Westinghouse Letter LTR-SGMP-09-100 NP-Attachment, "Response to NRC Request for Additional Information on H*; Model F and Model D5 Steam Generators" (questions 1 through 20 and 24 of the NRC RAI) (Non-Proprietary)

# Response to NRC Request for Additional Information on H*; Model F and Model D5 Steam Generators

August 12, 2009

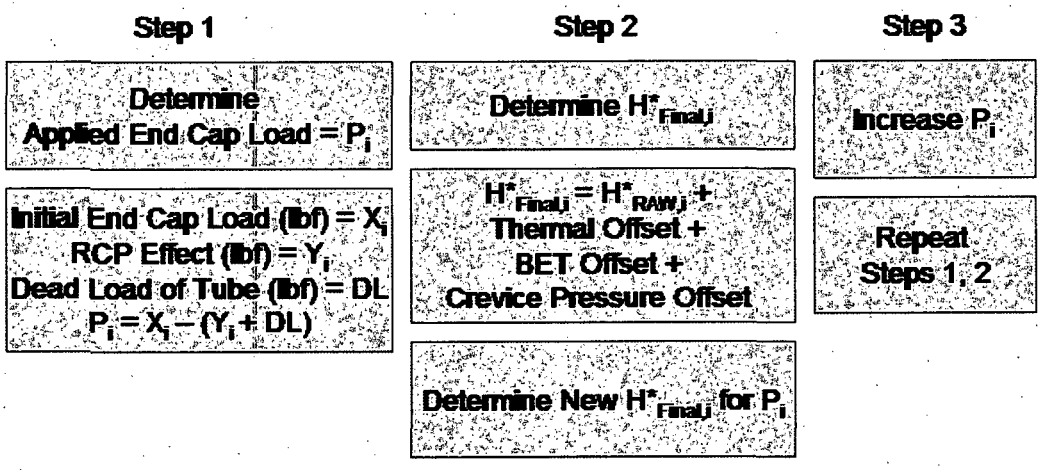
| ***RAI*** | *Vogtle* | *20. Section 8 of Reference 1: The variability of H* with all relevant parameters is shown in Figure 8-3. The interaction between $\alpha_T$ and $\alpha_{TS}$ are shown in Figure 8-5. Please explain why the direct relationships shown in these two figures were not sampled directly in the Monte Carlo analysis, instead of the sampling method that was chosen. Also, please explain why the sampling method chosen led to a more conservative analysis than directly sampling the relationships in Figures 8-3 and 8-5.* |

A value of H* is determined for any value of RCL for the limiting SG operating condition at the limiting TS radius and sector in the bundle. The process for determining the H* value is shown in the following flow chart.

The result of this process is a surface of the response in H* to changes in RCL and $\alpha_{srss}$ the square root of the sum of squares of the specific variations in CTE from one MC simulation). If the values for RCL are normalized to an assumed value, say [ ]$^{a,c,e}$ lbf, and the values of H* are taken as the change in H* relative to the value of H* with an RCL of zero, the result is a non-dimensional surface that can be used in conjunction with a Monte Carlo analysis to determine the reduction in H* due to the inclusion of RCL. Figure RAI20-9 is a surface plot of the change in the Model F H* values as a function of RCL and $\alpha_{srss}$. Figure RAI20-10 is a surface plot of the change in the Model D5 H* values as a function of RCL and $\alpha_{srss}$.
